## Observation Report

Re: Meadow Creek Condominiums, Vail, CO  
(Building C)  
Project No. 0307-19 C

(Image A)

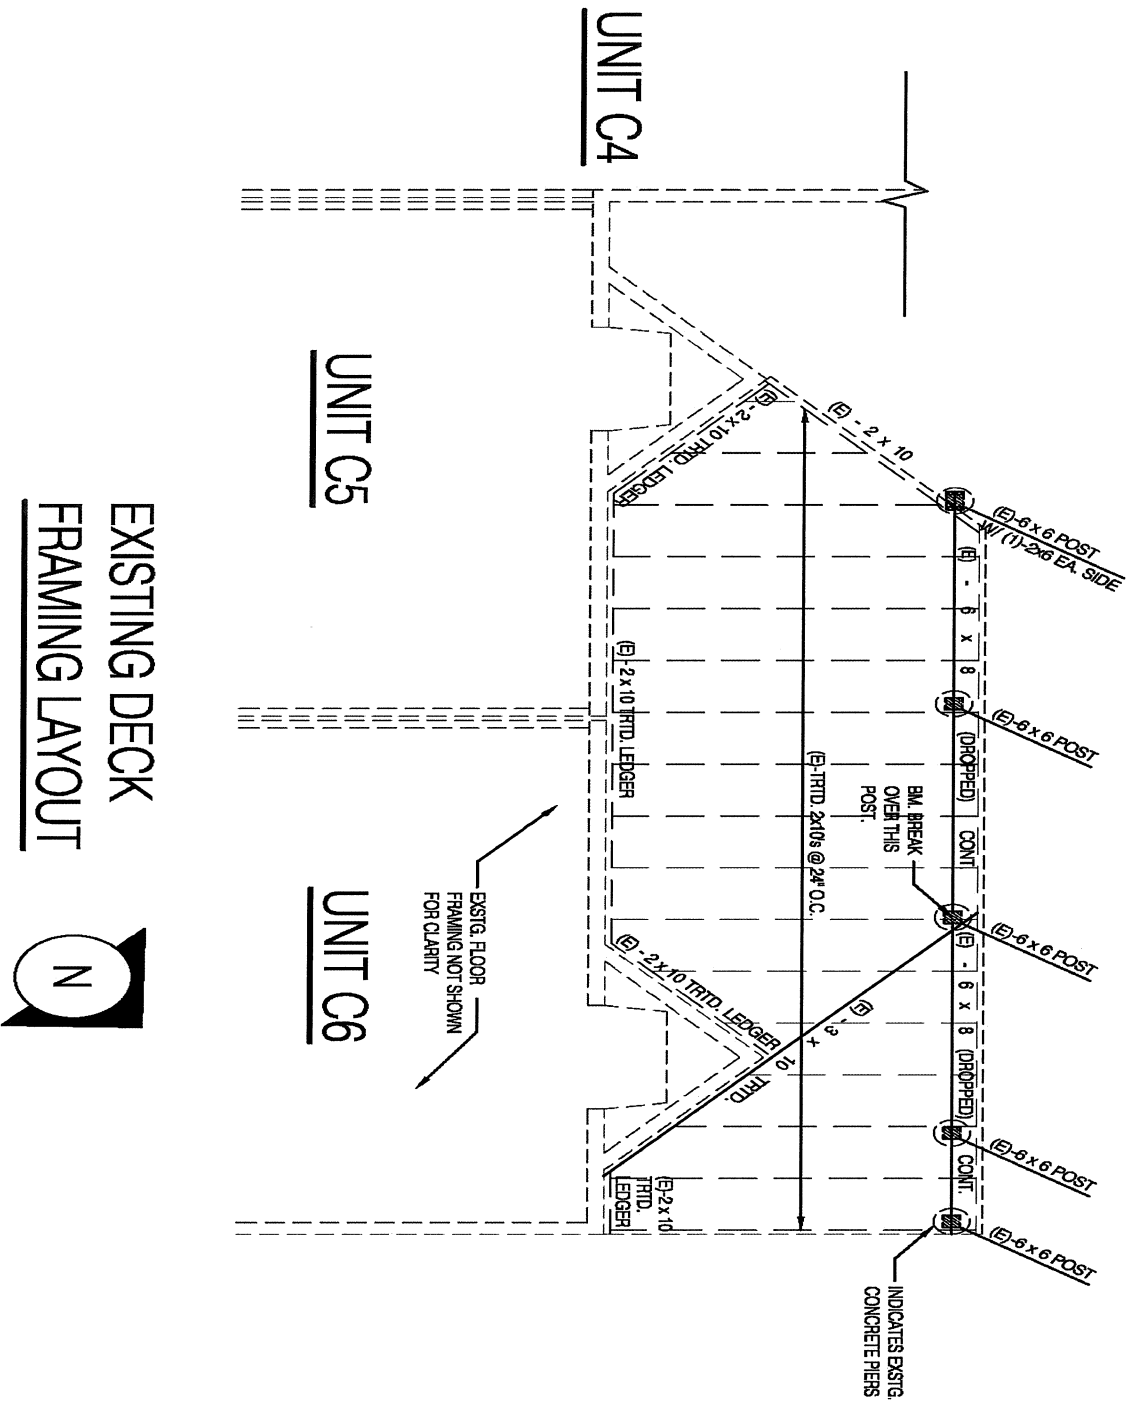
Building C consists of six units and stagger two units at a time from the northeast towards the southwest approximately 8 feet starting with units C6 and C5 on the northeast side. The exterior decks are located on the northwest side of the building and are approximately 11 to 13 feet above the finished grade. They extend approximately 9 feet from the building and the lengths of the decks vary from unit to unit. There is a framed partition wall that divides the decks in half. This partition wall appears to be located between the two units at the party wall. The decks are accessed by an exterior door located on the west side of each individual unit and an exterior set of stairs for Unit C1. The exterior decks appear to be framed with 2x wood decking, except for Unit C3 which has a composite material decking, on a combination of 2x10 dimensional lumber joists, timber beams and posts. (See Image A and attached layouts)
